# PARTICLE MEASUREMENT PROGRAMME

## **TASK FORCE 2 – BRAKE EMISSIONS**

**TF2 PROTOCOL – OPEN ITEMS**

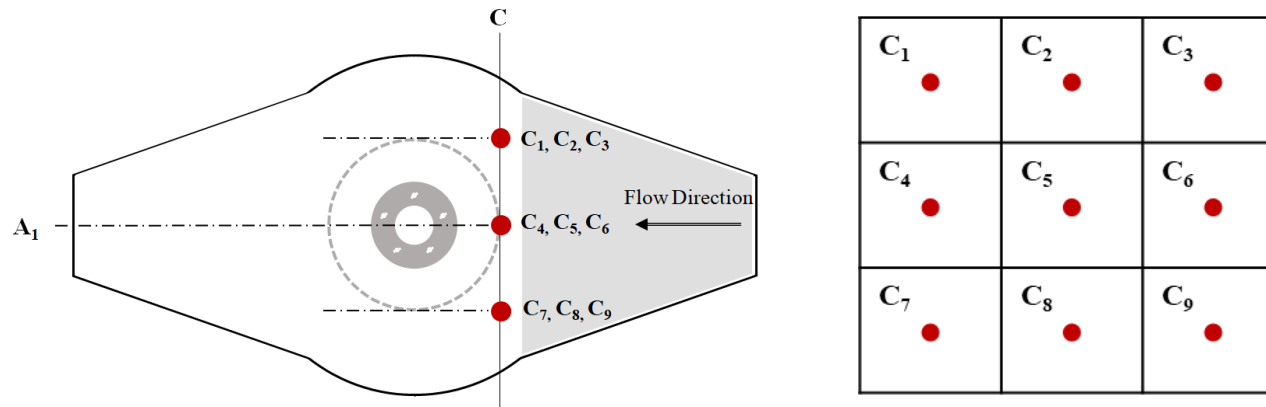
TOPIC: ***Background level*** – Excerpt from sub-clause 3.3.3 ***“The average background concentration in the tunnel shall not exceed the maximum limit of 10 #/cm<sup>3</sup> for both  $PN_{Back-Total}$  and  $PN_{Back-Solid}$ ”***

Comment: ***“We understand that the configuration of the measurement system is different from exhaust emission measurement system. Some systems consist of 2 stage diluter (Total DF: 100). Therefore, if the limitation is needed, we would like to propose <50 #/cm<sup>3</sup>. We think this is an appropriate limit by comparing it to the exhaust emission system even if the tunnel background is included.”***

JRC’s reply: Besides this comment there is consensus in TF2 with the proposed background limit. We have demonstrated that higher PN backgrounds (i.e. 50 #/cm<sup>3</sup>) lead to PN levels of E+09 for relatively high tunnel airflows. This is the level where most brake PN emission concentrations have been measured. Additionally, regen brakes are expected to be at even lower levels. Thus, we believe that a fixed dilution ratio of 1:100 will not allow for correct measurements and therefore labs shall be able to provide dilution ratios between 1:10 and 1:100.

JRC’s suggestion: Leave the background limit as is. As a compromise maybe set a background limit at 20 #/cm<sup>3</sup> – this would translate to PN background levels of 4E+08 #/km for a system operating at 850 m<sup>3</sup>/h, which still is considered acceptable for the emission levels observed at the ILS (but questionable for regen braking systems).
